# Access Compliance Report

## Public Rights-of-Way

Intersection ID: N/A	Main Street: BACK_CREEK_DR	Cross Street: W_T_HARRIS_BV	Location: NE
ADA ID: 0F1ACA2A6E73	Ramp Type: PerpDiag	Initial Pass/Fail: Pass	Overall Compliance: No
Severity Score: 0.25			
Codes/Mitigation Info/Possible Solution		Field Measurements/Component Compliance

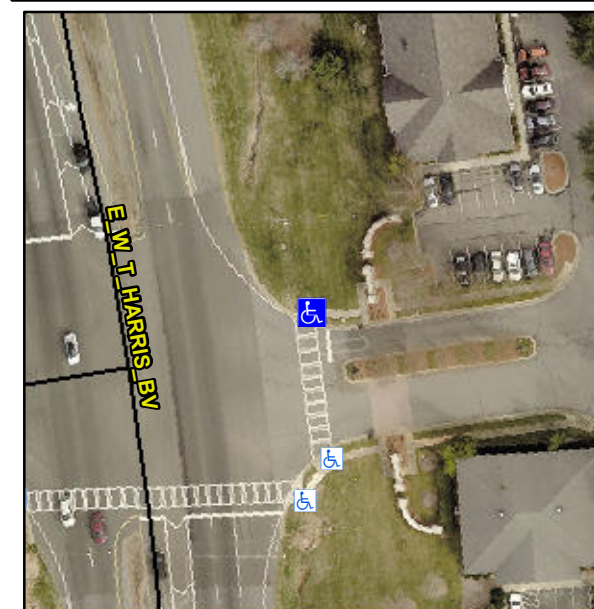
**Not Found, R304.5.3, R304.2.1**

Compliance	Description	Data	Compliance	Description	Data
N/A	Ramp Length (in)	49.0	Yes	Ramp Slope (%)	7.3
Yes	Ramp Width (in)	48.0	No	Ramp XSlope (%)	4.8
N/A	Flare Type LT	Sloped	N/A	Flare Type RT	N/A
N/A	Flare Slope LT (%)	6.8	N/A	Flare Slope RT (%)	8.7
N/A	Flare Traversable LT?	No	N/A	Flare Traversable RT?	No
No	Landing Length (in)	47.0	Yes	DWS Provided?	Yes
Yes	Landing Width (in)	48.0	Yes	DWS Contrast?	Yes
Yes	Landing Slope (%)	0.3	Yes	DWS Length (in)	24.0
No	Landing X Slope (%)	3.6	Yes	DWS Full Width?	Yes
N/A	Landing Curb? (Y/N)	No	Yes	DWS Offset (in)	2.0
N/A	Shared Landing?	No			
Yes	Gutter Ponding?	No	Yes	Gutter Slope (%)	4.6
Yes	Gutter Lip Ht (in)	0.0	Yes	Gutter X Slope (%)	2.6
N/A	Painted X Walk1?	No	N/A	Painted X Walk2?	Yes
	X Walk 1 Direction	To W		X Walk 2 Direction	To S
N/A	X Walk 1 Width (in)	N/A	N/A	X Walk 2 Width (in)	112.0
	X Walk 1 Slope (%)	3.1		X Walk 2 Slope (%)	3.1
	X Walk 1 X Slope (%)	1.7		X Walk 2 X Slope (%)	2.0

**Remove & Replace Curb Ramp With Two New Directional Ramps or Equivalent.**
